**SUNDRY NOTICES AND REPORTS ON WELLS**  
*Do not use this form for proposals to drill or to re-enter an abandoned well. Use form 3160-3 (APD) for such proposals.*

8. Well Name and No.  
COTTON DRAW UNIT 222H

Devon Energy Production Co. L.P. respectfully requests to use a FMC uni-head system for the subject well.

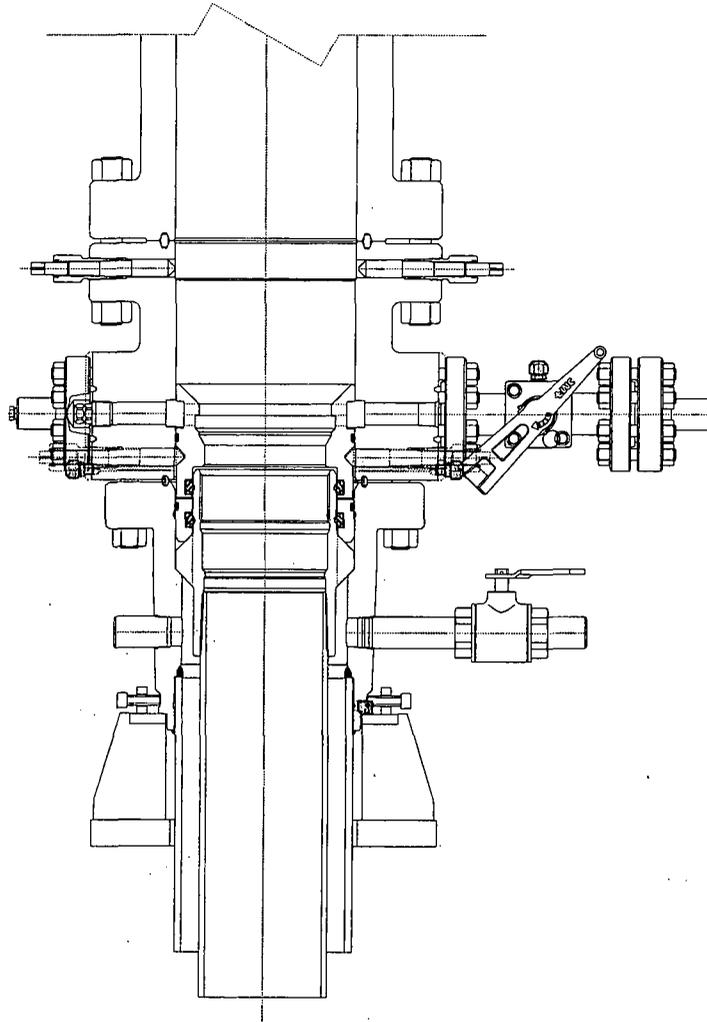
Devon proposes using a multi-bowl wellhead assembly (FMC Uni-head). This assembly will only be tested when installed on the surface casing. Minimum working pressure of the blowout preventer (BOP) and related equipment (BOPE) required for drilling below the surface casing shoe shall be 3000 (3M) psi.

- Wellhead will be installed by FMC's representatives.
- If the welding is performed by a third party, the FMC's representative will monitor the temperature to verify that it does not exceed the maximum temperature of the seal.

- FMC representative will install the test plug for the initial BOP test.
- FMC will install a solid steel body pack-off to completely isolate the lower head after cementing intermediate casing. After installation of the pack-off, the pack-off and the lower flange will be tested to 5M, as shown on the attached schematic. Everything above the pack-off will not have been altered whatsoever from the initial nipple up. Therefore the BOP components will not be retested at that time.

- If the cement does not circulate and one inch operations would have been possible with a standard wellhead, the well head will be cut and top out operations will be conducted.

- Devon will pressure test all seals above and below the mandrel (but still above the casing) to full working pressure rating.
- Devon will test the casing to 0.22 psi/ft or 1500 psi, whichever is greater, as per Onshore Order #2.

3. **Operator has proposed a multi-bowl wellhead assembly. This assembly will only be tested when installed on the surface casing. Minimum working pressure of the blowout preventer (BOP) and related equipment (BOPE) required for drilling below the surface casing shoe shall be 3000 (3M) psi.**

- a. **Wellhead shall be installed by manufacturer's representatives, submit documentation with subsequent sundry.**
  - b. **If the welding is performed by a third party, the manufacturer's representative shall monitor the temperature to verify that it does not exceed the maximum temperature of the seal.**

- c. **Manufacturer representative shall install the test plug for the initial BOP test.**
  - d. **Operator shall perform the intermediate casing integrity test to 70% of the casing burst. This will test the multi-bowl seals.**

- e. **If the cement does not circulate and one inch operations would have been possible with a standard wellhead, the well head shall be cut off, cementing operations performed and another wellhead installed.**

PRIMARY MODE

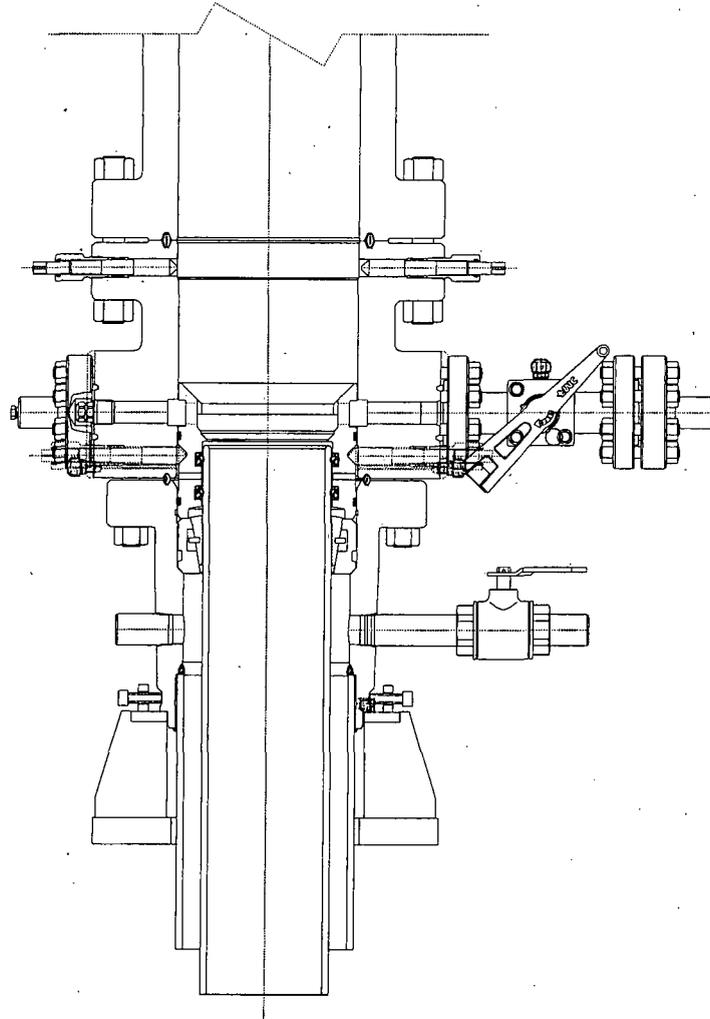
After running the 13-3/8" surface casing, a 13-5/8" BOP/BOPE system with a minimum rating of 3M will be installed on the FMC Uni-head wellhead system and will undergo a 250 psi low pressure test followed by a 3,000 psi high pressure test. The 3,000 psi high and 250 psi low test will cover testing requirements a maximum of 30 days, as per Onshore Order #2. If the well is not complete within 30 days of this BOP test, another full BOP test will be conducted, as per Onshore Order #2.

After running the 9-5/8' intermediate casing with a mandrel hanger, the 13-5/8" BOP/BOPE system with a minimum rating of 3M will already be installed on the FMC Uni-head.

The pipe rams will be operated and checked each 24 hour period and each time the drill pipe is out of the hole. These tests will be logged in the daily driller's log. A 2" kill line and 3" choke line will be incorporated into the drilling spool below the ram BOP. In addition to the rams and annular preventer, additional BOP accessories include a kelly cock, floor safety valve, choke lines, and choke manifold rated at 3,000 psi WP.

Devon requests a variance to use a flexible line with flanged ends between the BOP and the choke manifold (choke line). The line will be kept as straight as possible with minimal turns

2. Variance approved to use flex line from BOP to choke manifold. Check condition of flexible line from BOP to choke manifold, replace if exterior is damaged or if line fails test. Line to be as straight as possible with no hard bends and is to be anchored according to Manufacturer's requirements. The flexible hose can be exchanged with a hose of equal size and equal or greater pressure rating. **Anchor requirements, specification sheet and hydrostatic pressure test certification matching the hose in service, to be onsite for review. These documents shall be posted in the company man's trailer and on the rig floor.** If the BLM inspector questions the straightness of the hose, a BLM engineer will be contacted and will review in the field or via picture supplied by inspector to determine if changes are required (operator shall expect delays if this occurs).
